AS-GRADED PLOT PLAN

ORDERED BY: KENNEY HOMES
DESCRIPTION: LOT 26, VILLAS AT MEADOWS AT SUMMIT RIDGE 12TH, PLAT IN LEE'S SUMMIT, MO

3320 SW JESSIE LN.

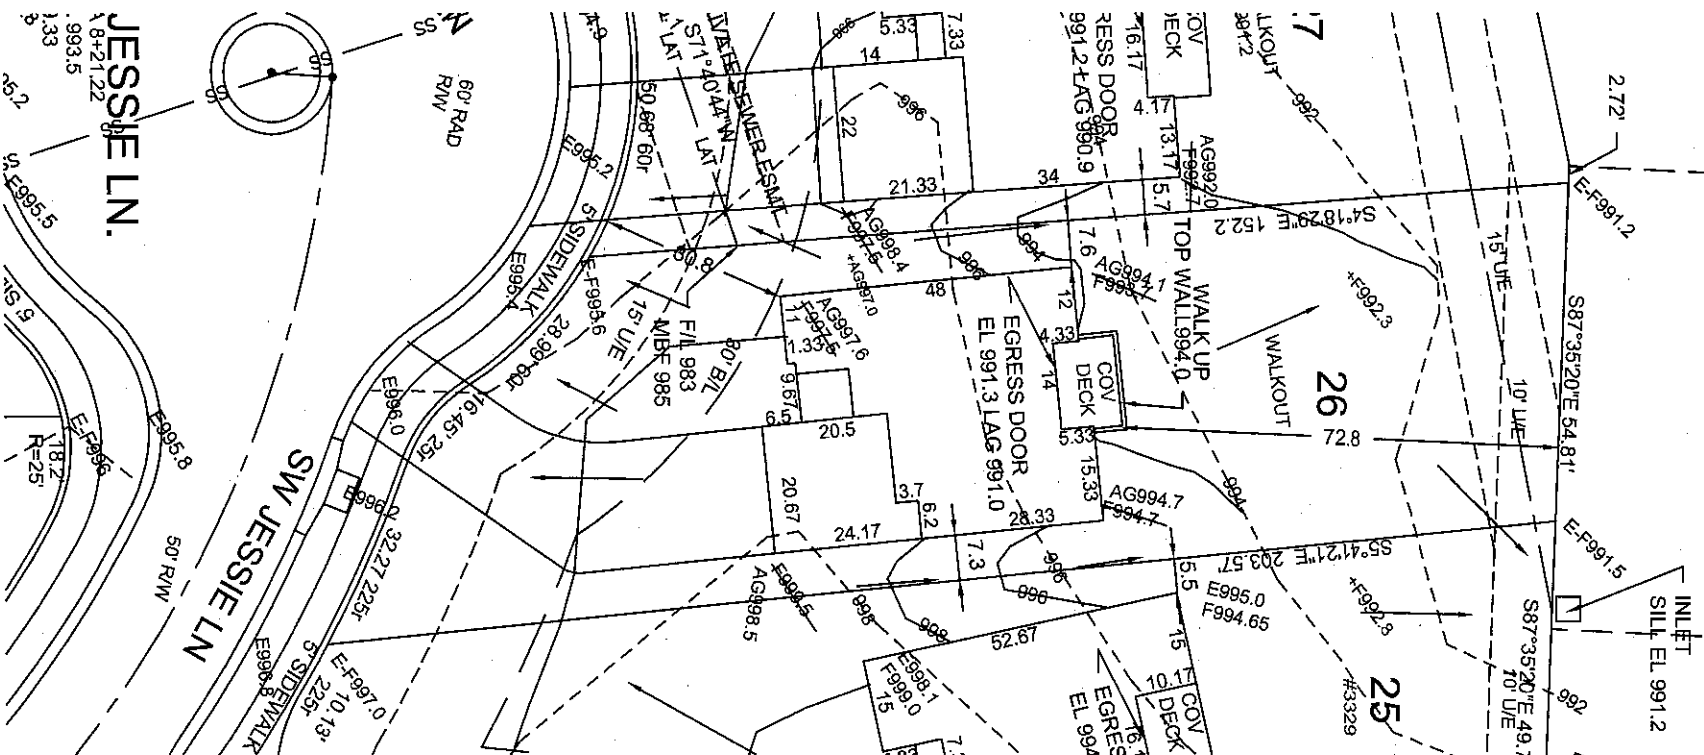
THIS LOT WAS PREVIOUSLY APPROVED
FOR A DAYLIGHT, BUT THE BUILDER
FORCED A WALKOUT WALK UP WITHOUT APPROVAL.
THE BUILDER MUST MEET 2% POSITIVE
DRAINAGE REQUIREMENT.
